**ARRIEL 2****Application : Mandatory****Subject : Compressor module. Installation of a sleeve in the attachment boss of the bleed valve.****Incorporation of the modification TU 54.**

**Original issue : 20.09.1999****Update No ... from ...****292 72 2054****Page 1/6****TURBOMECA 40220 Tarnos - FRANCE****Tél. (33) 05 59 64 40 00 - Télex 570 042 - Fax (33) 05 59 64 60 80**

**Montage du fourreau**  
**Sleeve installation**

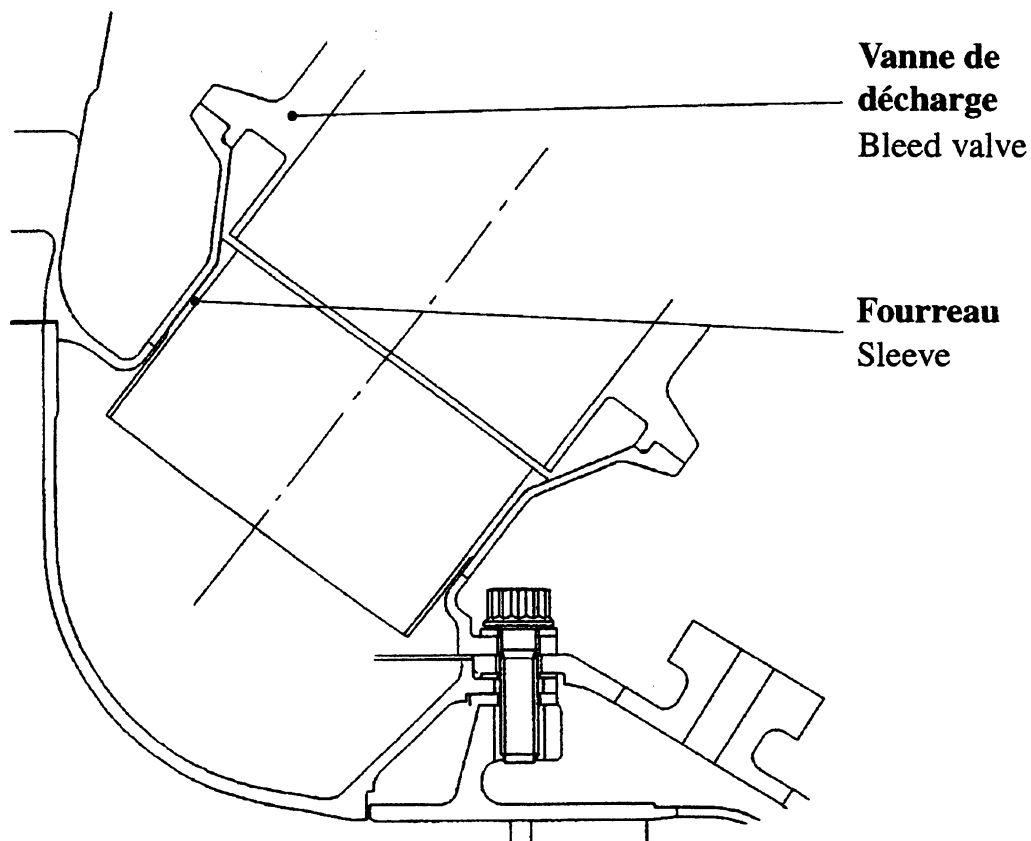
To reduce the vibratory level of the compressor blades by deleting coupling which may occur through the air flow between these blades and the acoustic cavity between the compressor cover and casing. Deleting this coupling is obtained by disturbing the symmetry of this cavity by the insertion of a metal sleeve.

This vibratory level may lead to initiation of cracks on the blades which can lead to rupture of a blade and result in an in-flight power loss and possibly in an uncommanded in-flight shutdown.

This modification consists of inserting a sleeve in the attachment boss of the bleed valve.

(b) **Install the sleeve** at the very bottom of the boss attachment of the bleed valve : refer to appendix 1.

**Note** : The sleeve slot is used to ensure the elasticity required to maintain it in position, but does not require any special positioning.
